CONSTRUCTION TRAFFIC IMPACT ASSESSMENT GREENWICH HOSPITAL REDEVELOPMENT

SSD-13619238-MOD-2
REQUEST FOR INFORMATION

26 May 2026

This report has been updated to address recent comments from DPHI as tabulated below. Our response to each comment and reference to report updates are also provided below.

Figure 2: Estimated Construction Traffic Distribution Routes

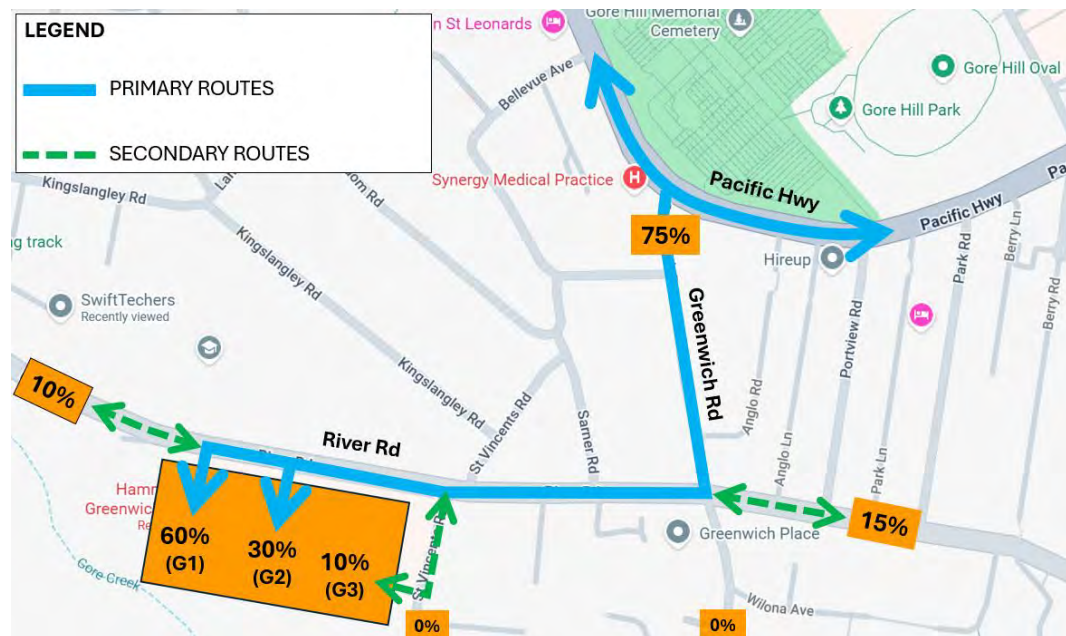
Matter	Discussion	Action / Response required	SITE Traffic Response
	It is noted there is a truck ban on St Vincents Rd south of River Rd, restricting trucks above 3 tonnes(t). The truck ban has not been identified in the TIA and may require redistribution of heavy vehicles away from Gate 3.		Traffic modelling in Sections 3 and 5 of this report has been updated to reflect this.
Estimate trip generation	Appendix C (CMP, May 2022) of the TPIA developed for the original EIS (May 2022) presented the original assumptions for traffic volumes. Table is Section 4.1.2.1 provides 'deliveries per day' and 'deliveries per hour' for bulk excavation, structure, fitout and finishes, landscaping / external works. There is no table providing traffic numbers for Stage 3. Given that works were initially proposed to be sequential, the numbers initially provided were a worst-case scenario for any given stage.	Clarify the traffic generation assumptions to demonstrate that both Stage 2 and Stage 3 traffic numbers were forecast, then combined for the concurrent construction of Stage 2 and Stage 3.	The main contractor has confirmed the estimated traffic generation adopted in this report is representative of a typical construction day. These traffic volumes are based on the construction methodology, noting that while Stages 2 and 3 are being undertaken concurrently, the rate of activities such as demolition and excavation is not expected to increase, and therefore overall traffic generation is not anticipated to exceed previously assessed levels.

The distribution of construction related traffic to/from the site is estimated to predominantly travel via routes shown in Figure 2.

For the purpose of this assessment, these routes and distribution percentages apply to all construction related heavy vehicles (HVs) and light vehicles (LVs).

Figure 3: Estimated Mid-Block Construction Traffic Volumes

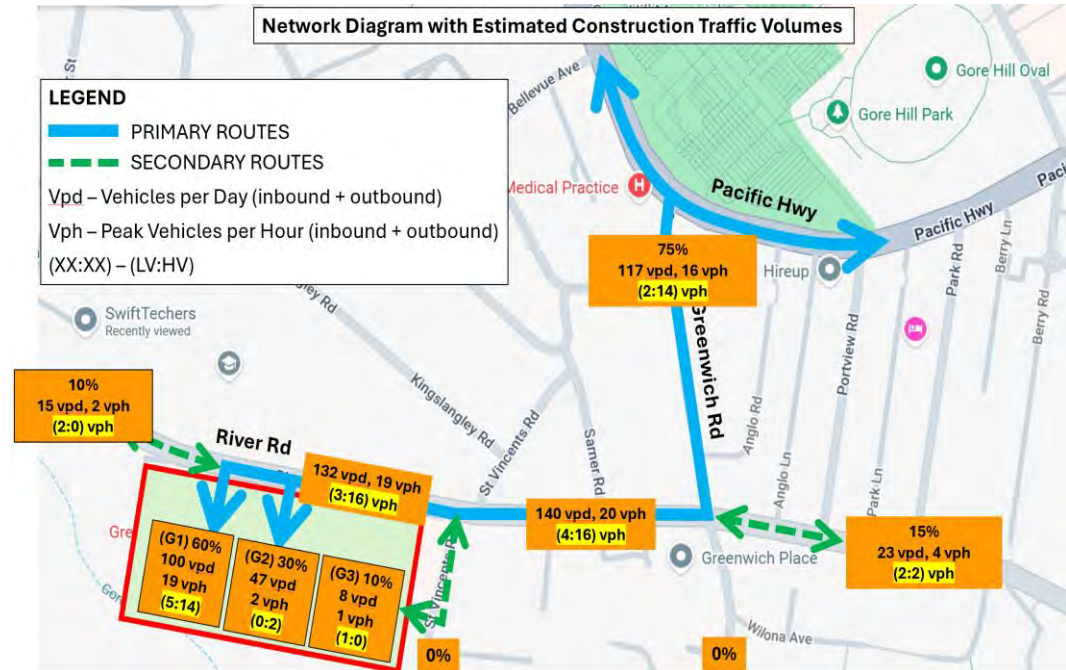
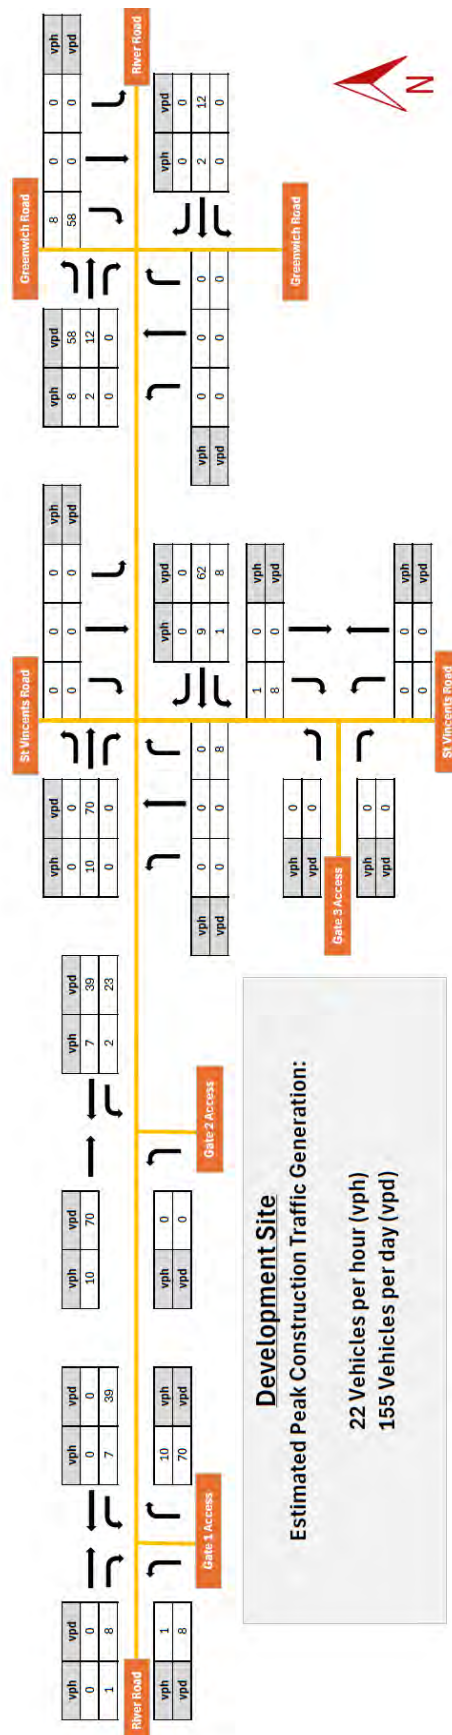
Matter	Discussion	Action / Response required	SITE Traffic Response
	Now that stages are combined, we require the traffic generation volumes for both Stage 2 and Stage 3 and then combined (i.e. an explanation of where the traffic volumes are coming from). It would be anticipated that a combined scenario would have higher volumes than those initially provided.		
Defining deliveries and movements	It should be noted that the construction traffic generation was originally identified as deliveries in Appendix C of the CMP 2022, however when reported within the main body of the CTPMSP (Nov 2024 version), the construction traffic generation is now identified as movements rather than deliveries.	Clarify the use of 'deliveries' or 'movements' within the construction traffic generation as this will have a further impact on the total construction demand to the site.	The traffic volumes presented in Section 3.5.1 of this report are based on 'deliveries' which also shown the Inbound and Outbound movements.

Matter	Discussion	Action / Response required	SITE Traffic Response
	The application of 'deliveries' compared to 'movements' has an impact on the construction traffic generation for the site. A delivery would be one trip into the site and one trip out (a total of two movements), where a movement is a single movement in either direction. Appendix C of the TPA 2022 report refers to 22/23 deliveries, which would have generated up to 46 movements at the site. However, the TIA (April 2026 – Section 2.5.1) referring to movements would only generate up to 22 movements at the site.		
Construction vehicle distribution	The current split amongst the three gates shows that 10% of Project traffic will use Gate 3 on St Vincent Rd.	Confirm that a maximum of 10% of Project generated construction traffic would use St Vincents Rd (i.e. no increase above 10% for the combined staging of Stage 2 and Stage 3).	This assessment, and clarification from the main contractor, estimates a maximum of 10% use of Gate 3. As previously noted, it is also estimated that the majority of traffic using Gate 3 will typically be inbound movements.

Based on the above, the indicative split between construction related heavy vehicles using the adjacent road network is shown in Figure 3 and Figure 4 overleaf (also refer to **Appendix A**).
